ADA AND UNIVERSAL DESIGN IN PARKS AND RECREATION: Accessibility Audit of City Central Park Walker, MI

Kim M. Frost, Access Specialist
Disability Advocates of Kent County
6/25/2013

RE: Accessibility Audit and Training, City Central Park, Walker

Figure 2: Access Audit route. *Original image taken from Google Maps*

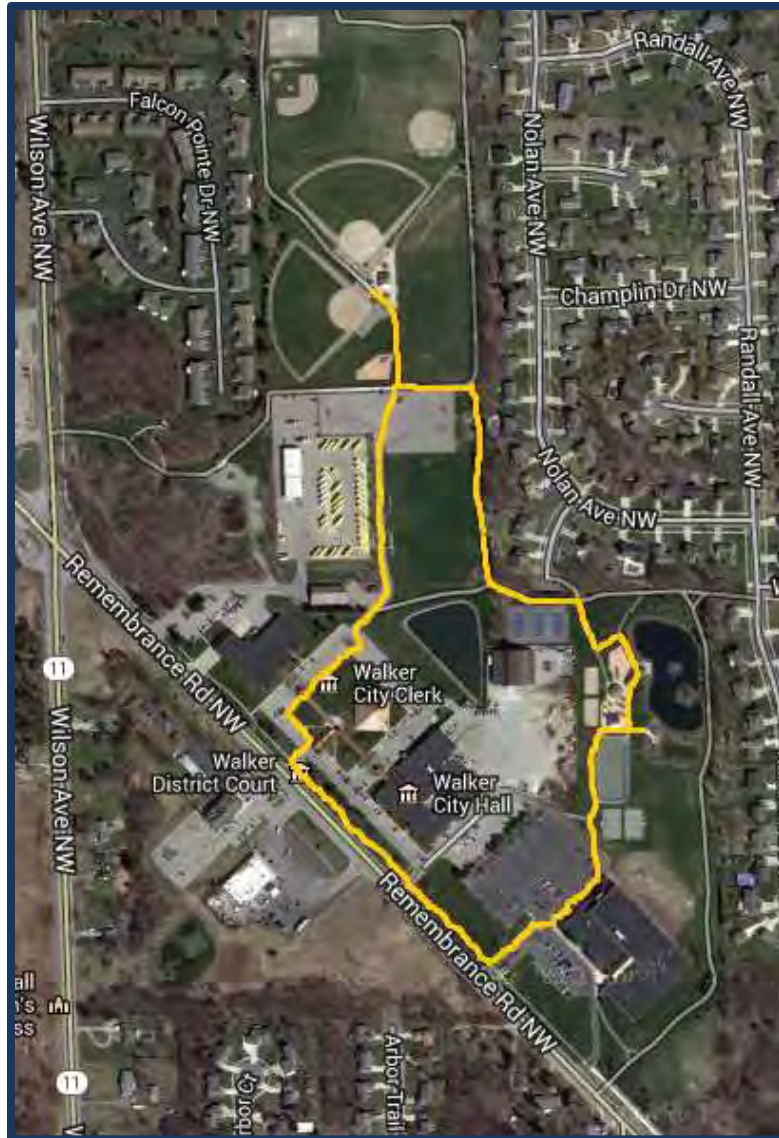
A representative sample of existing trails and sidewalks was evaluated in the June 5, 2013 audit. The evaluation began at the trailhead to the northwest of the Ice and Fitness Center, and continued north until turning west at the tennis courts. At the eastern edge of the retention pond, the audit again turned north, turned west at the southern edge of the soccer fields, turned north to the western edge of the soccer fields and continued to the concession building next to the main baseball diamonds.

From the baseball diamonds, the audit moved south along the driveway, turning southwest between the Fire Department Station #1 and the Public Library until connecting with the Remembrance Road sidewalk. The audit then turned southeast until it reached the entrance for the Walker Ice and Fitness Center, where it proceeded northeast to complete the loop.

Figure 30: Front bumper overhangs sidewalk reducing space for comfortable mobility. *Photo courtesy Marylu Dykstra, Disability Advocates of Kent County.*

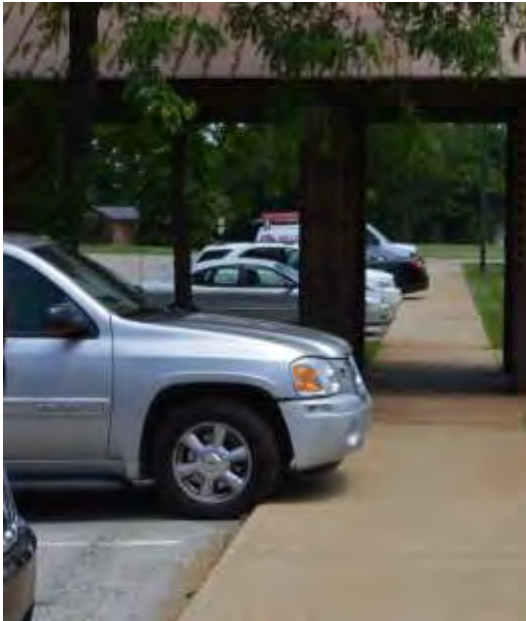
Providing access is also defined by allowing people to move uninhibited from one area to another. This may require adjustments to parking areas and adjacent sidewalks to accommodate the space required for mobility equipment. (Figure 30)
